Model	DJF for F401 / F411 / F421 / Lily	Volt/Hz	Date of Modification	Serial Number
Modified Article	Screw			
Reason for Modification	To prevent screws from becoming loose

Model: DJF for F401 / 411 / 421 / Lily		Date: 15-Mar-97	No: 002	1/2
Modified Article: Feed-out Drive Roller Holder			Prepared by: F. Noguchi	
From: QAC 1st Field Information Dept.			Checked by: T. Inoue <i>T. Inoue</i>	
Reason for Modification:	☐ Parts catalog correction	☐ Vendor change	☐ To meet standards	
	☐ To facilitate assembly	☒ To improve reliability	()	
	☐ Part Standardization	☐ Other

Feed-out Driven Roller Holder

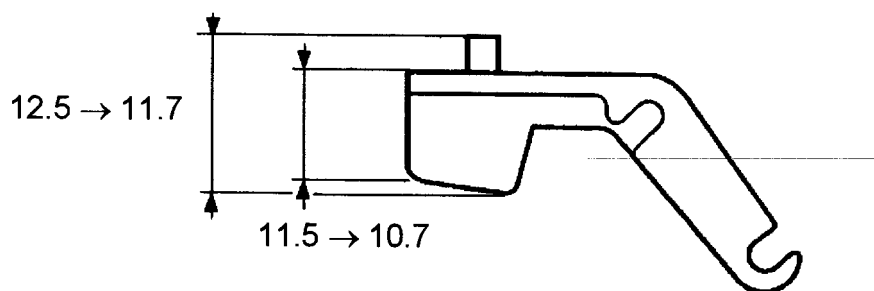
To increase the gap between the feed-out driven roller holder and the lower cover, the shape of the feed-out driven roller holder has been changed

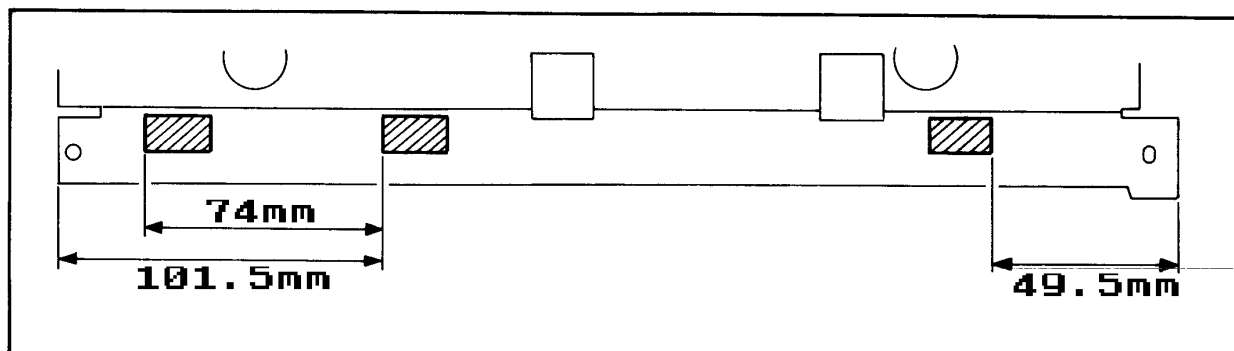
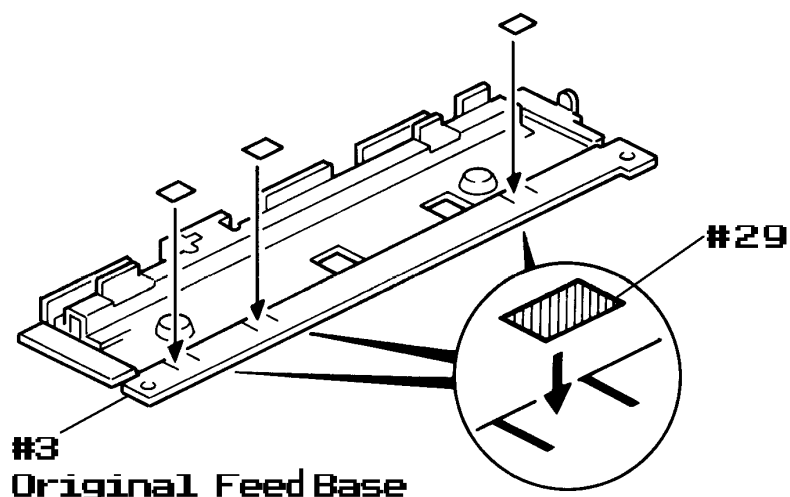
To prevent detection errors, sensor seals (black) have been attached to the original feed base.

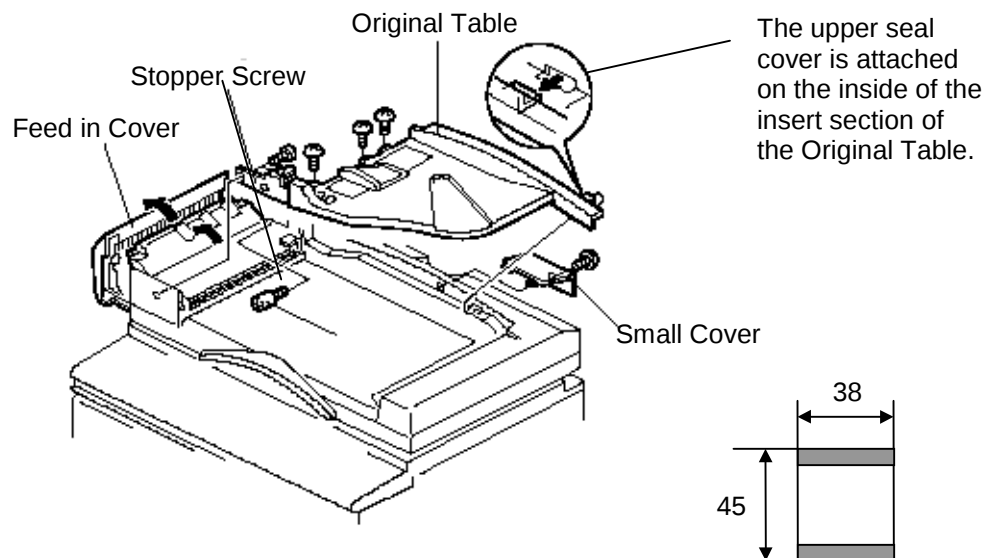
Foreign material (staples, etc.) may enter through the DF and drop down onto the main board and cause it to short-circuit. To prevent the introduction of foreign material, the upper cover seal has been added.

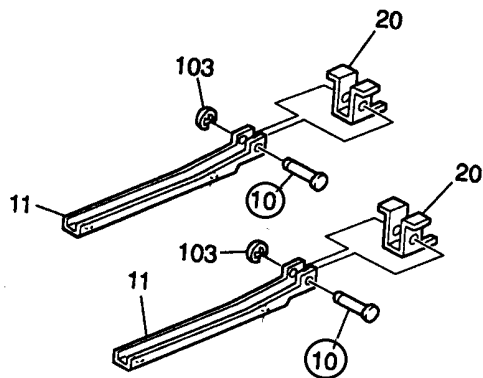
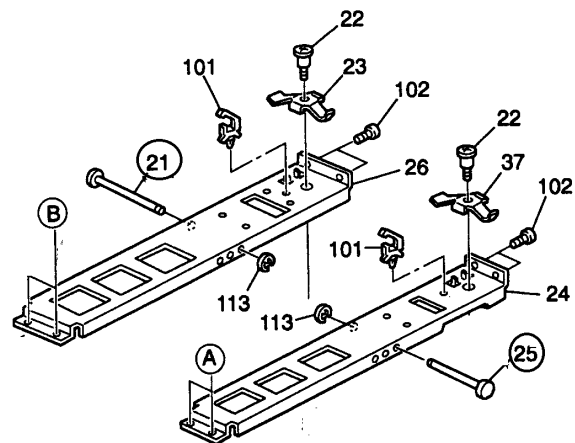
To facilitate assembly, E-rings will be placed on only one end of the following shafts.

Page 6

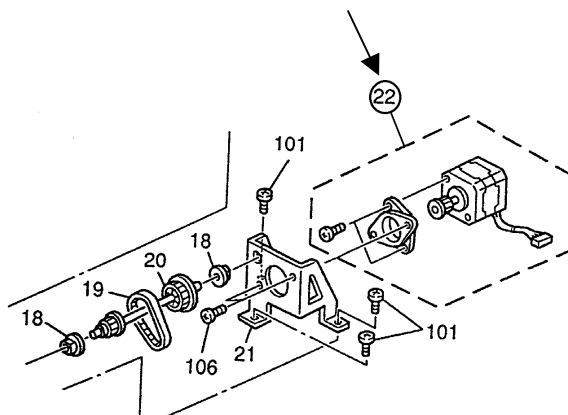
22: A6101530→A6101531

Page 10

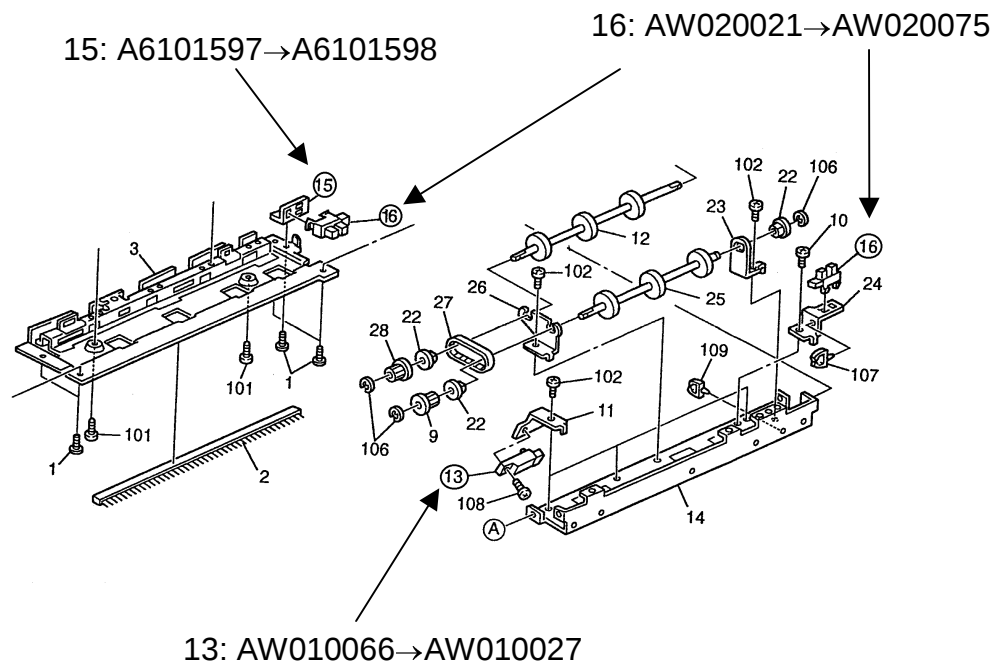
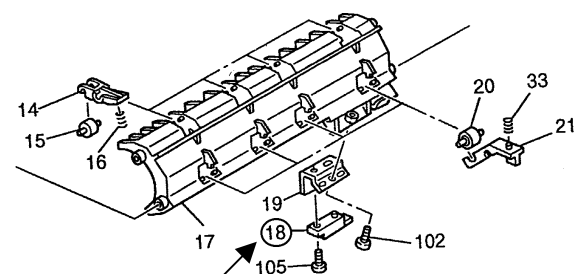
* When replacing with the new photointerrupter (16), be sure to use the new sensor bracket (15).

Page 14

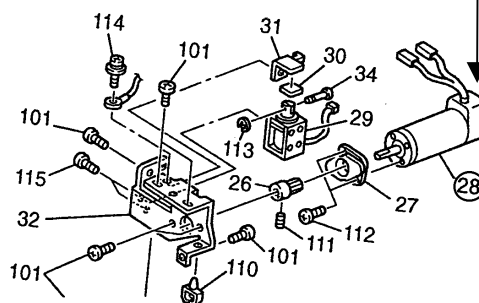
18: AW010066→AW010027

28: AX060082→AX060160

Page 16

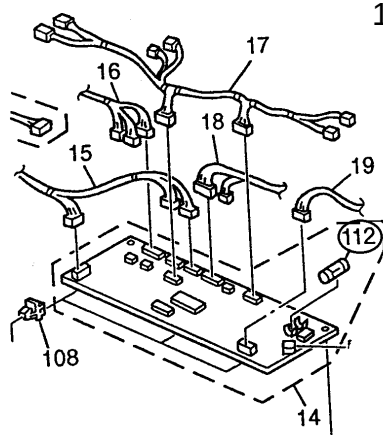
112: 11070752→11070884

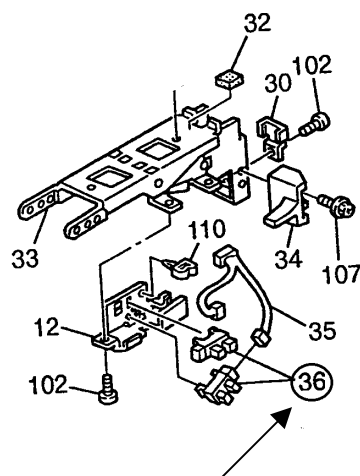
36: AW020021→AW020075

Page 8

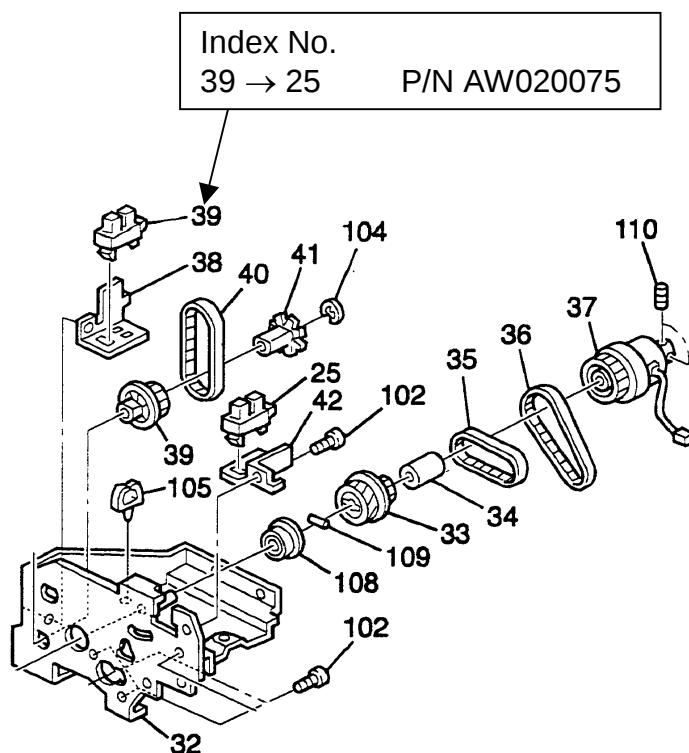
Index No. Correction (in the Illustration)
Please correct your parts catalog as follows:
